STAFF RECOMMENDATION

**520 Fairfax Avenue
December 19, 2012**

Application: New construction – accessory building, Demolition-accessory building and Setback reduction

1 SITE PLAN

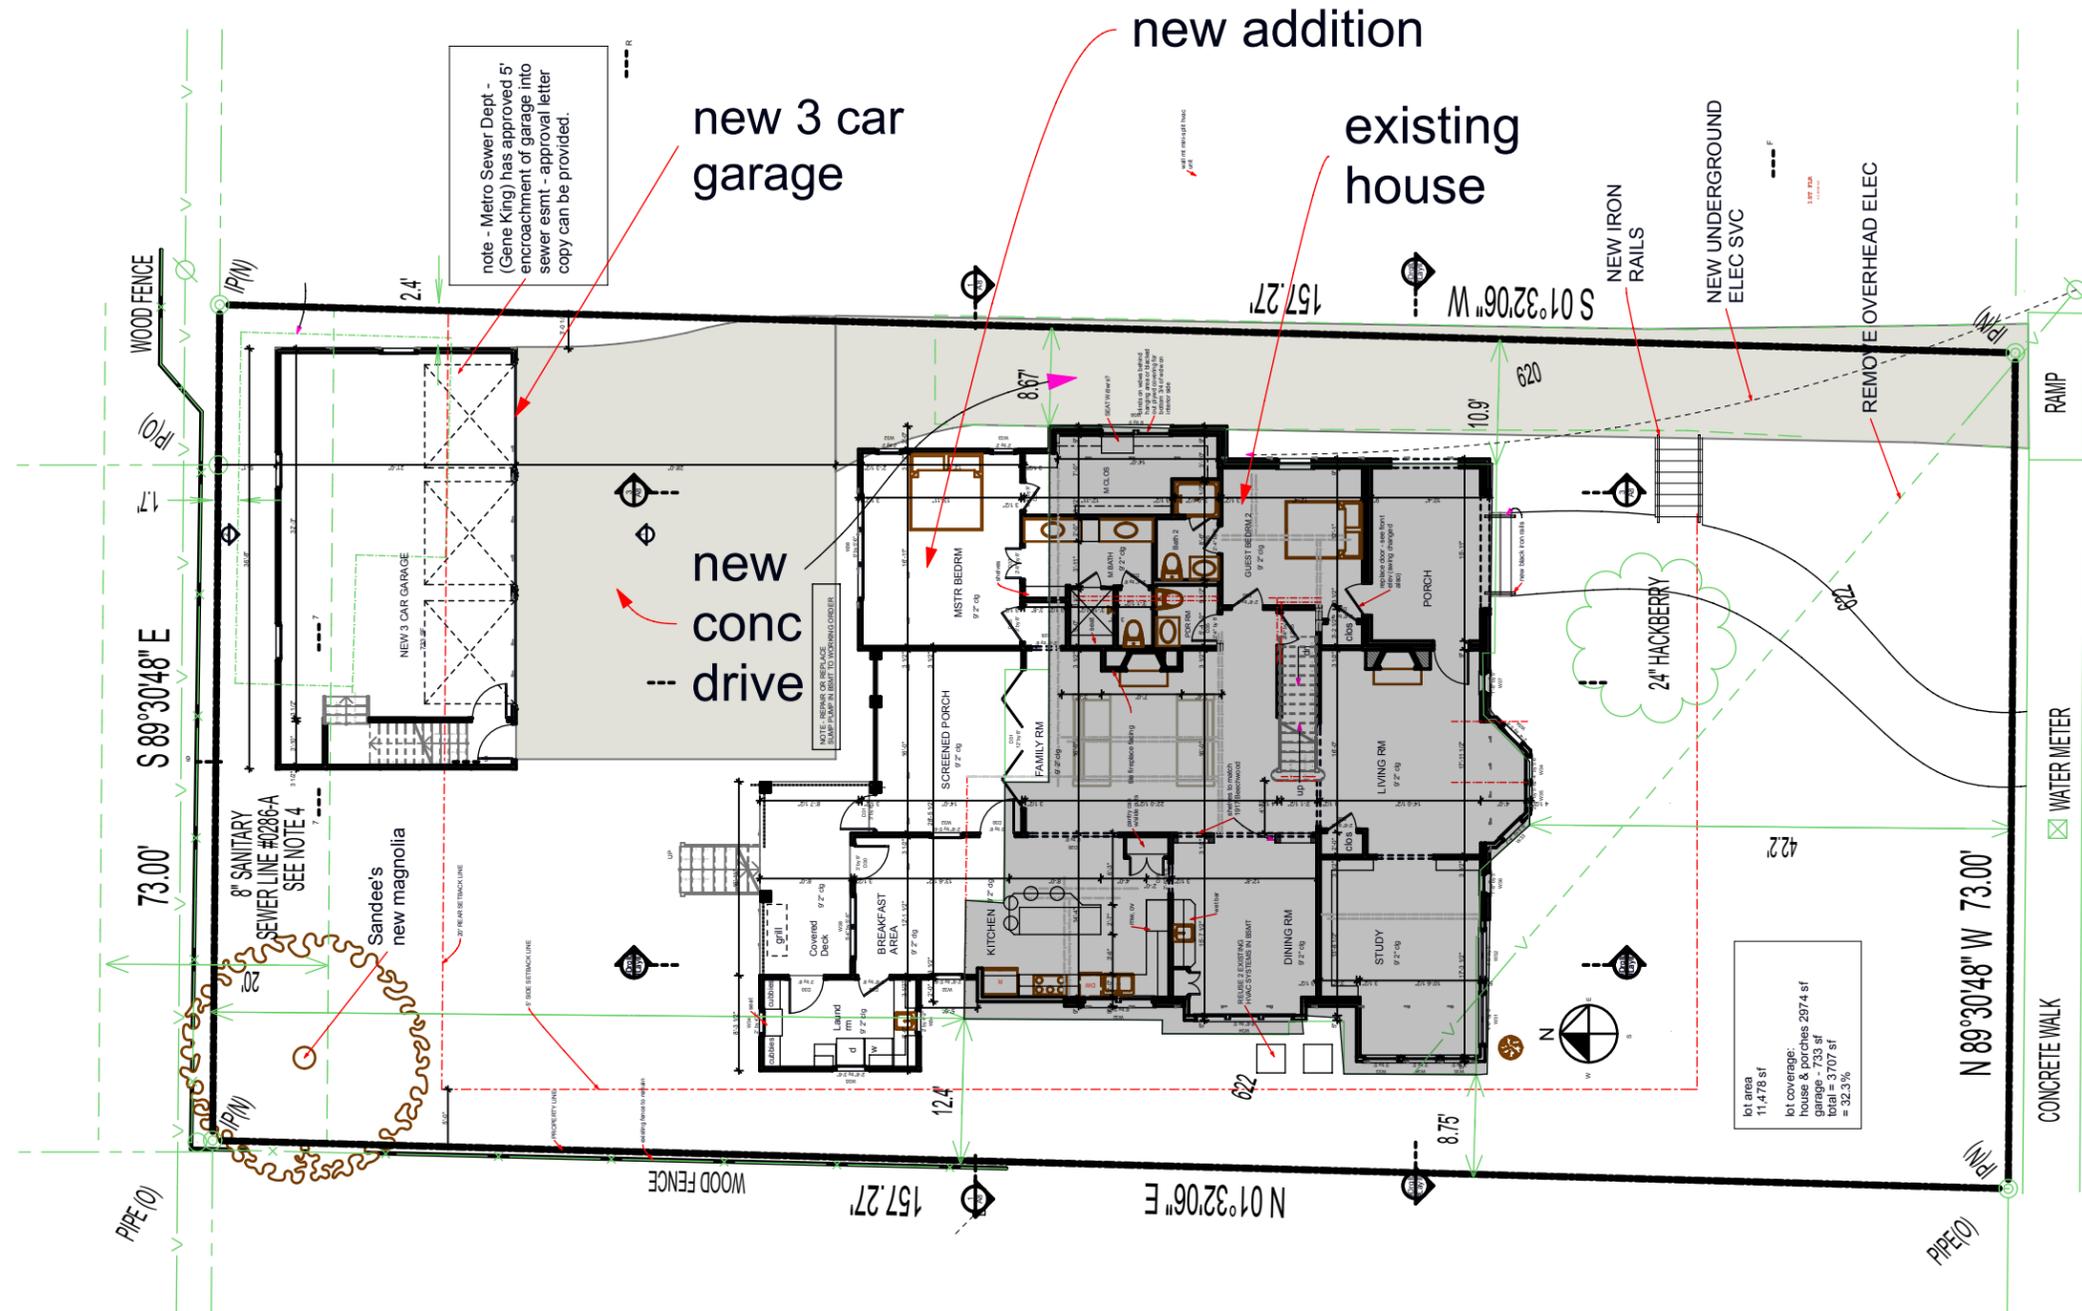
The proposed garage is located towards the rear of the property, at the end of an existing driveway, as seen historically in this neighborhood. The side setback is approximately three and one-half feet (3.5’) at its closest point and the rear setback is five feet (5’). The rear setback meets bulk zoning because the garage doors face the house rather than a rear alley as there is no alley at this location. Because of the size of the structure, a five foot (5’) side setback is required by bulk zoning, rather than the typical three feet (3’). Due to the size of the structure and existing conditions, staff did not find that the project met the

requirements for a recommendation of a side setback reduction. The applicant has agreed to move the building over so that the minimum setback of five feet (5') is met. With this condition, the project meets section II.B.1.c and h.

Staff recommends approval with the conditions that the building have a minimal side setback of five feet (5'), staff provide final review of windows, doors and roof color prior to purchase and installation and that the street facing dormer sit back from the wall at least 24".

GARAGE

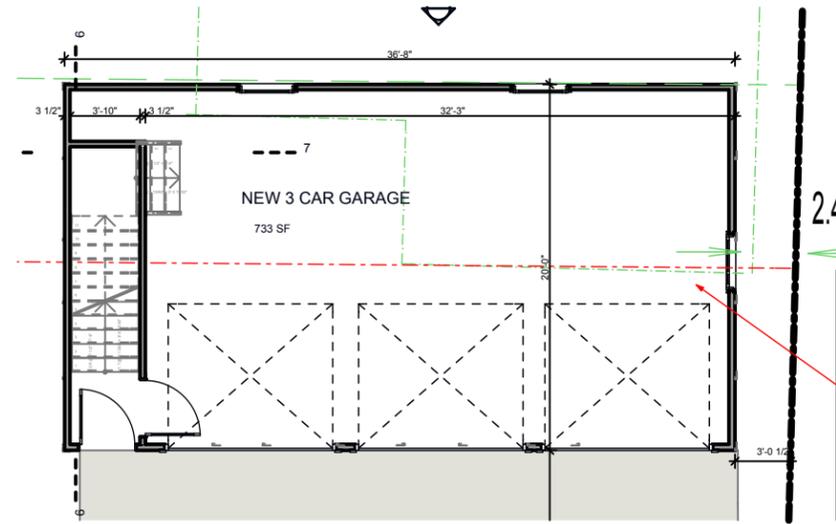
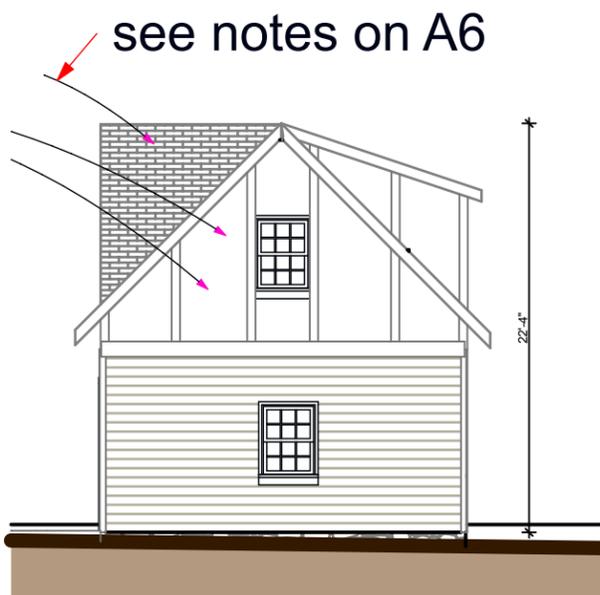
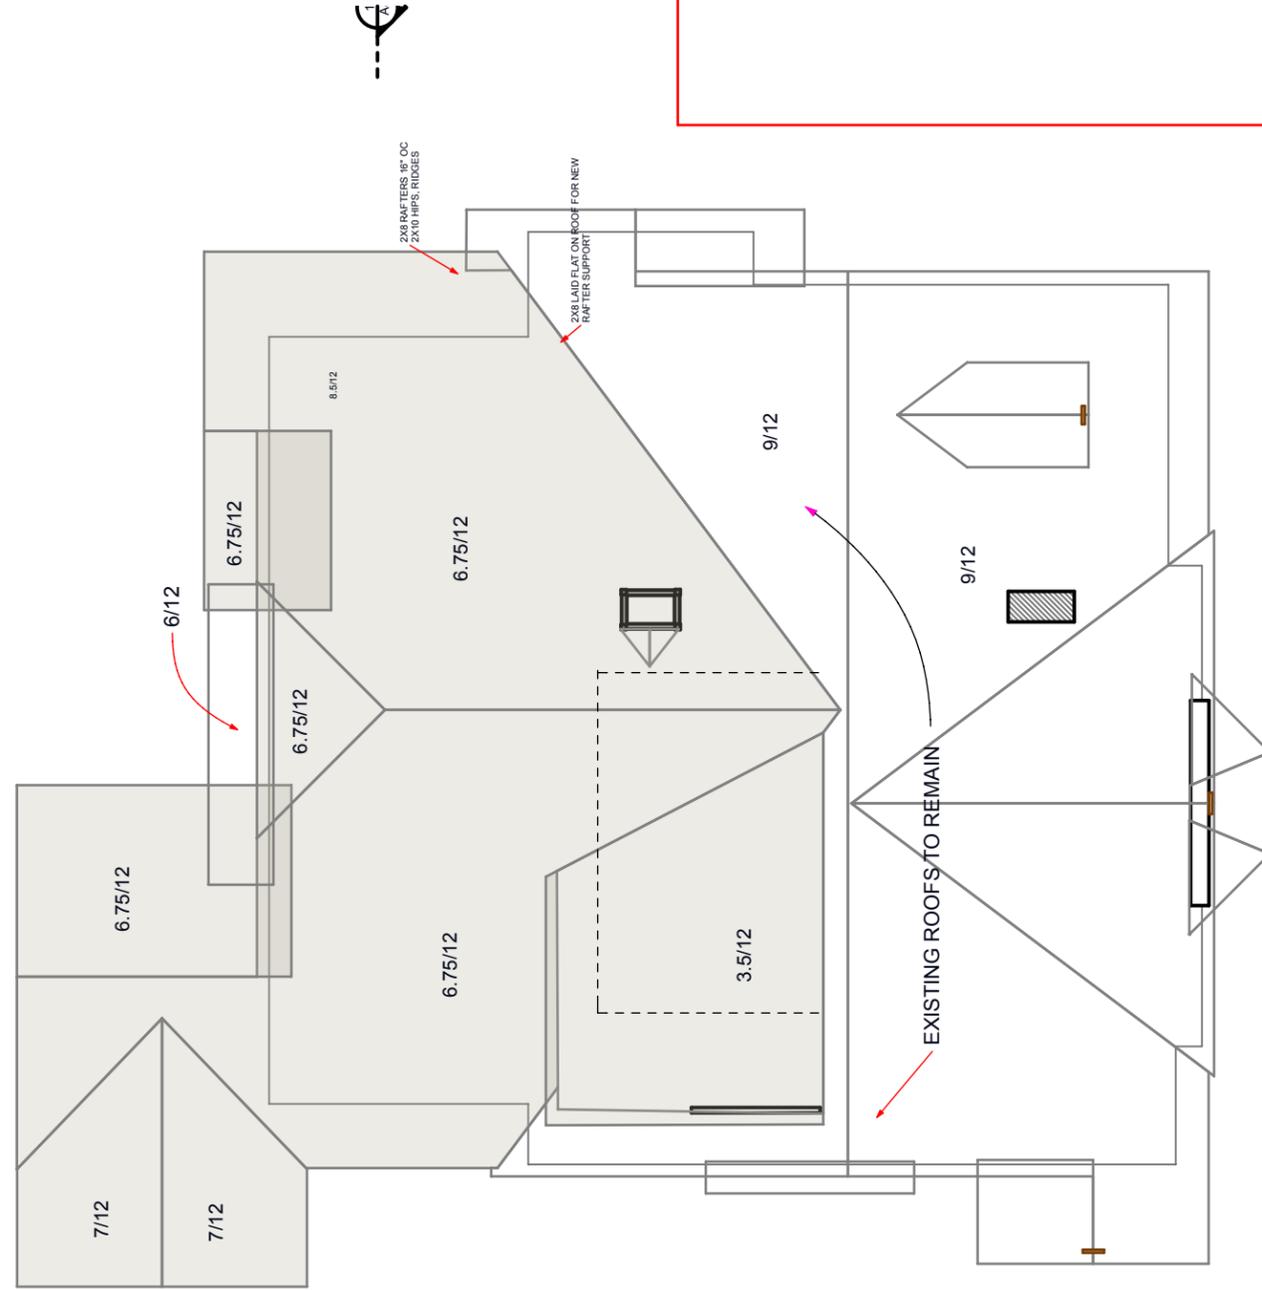
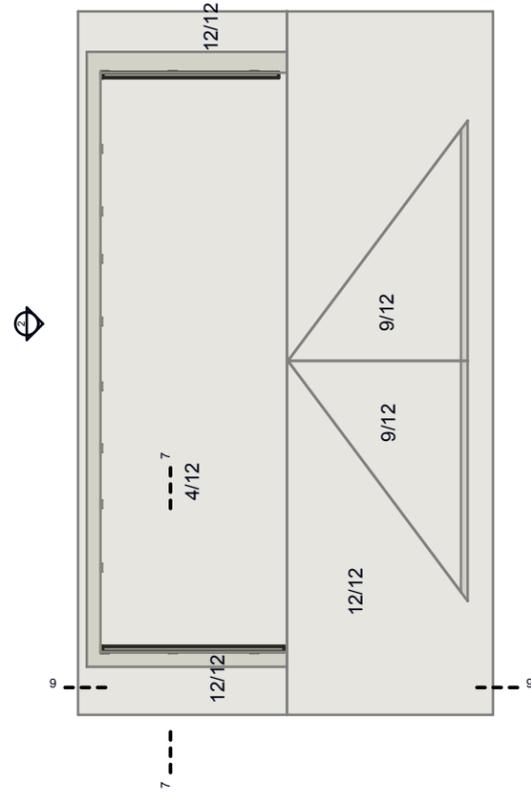
The primary roof pitch is 12/12 compared to the 9/12 pitch of the main house. The proposed pitch is typical of historic buildings in the neighborhood. The design guidelines require dormers on street-facing sides of garages sit back from the front wall a minimum of two feet (2'). The applicant has agreed to this condition and so the project meets section II.B.1.e and h.
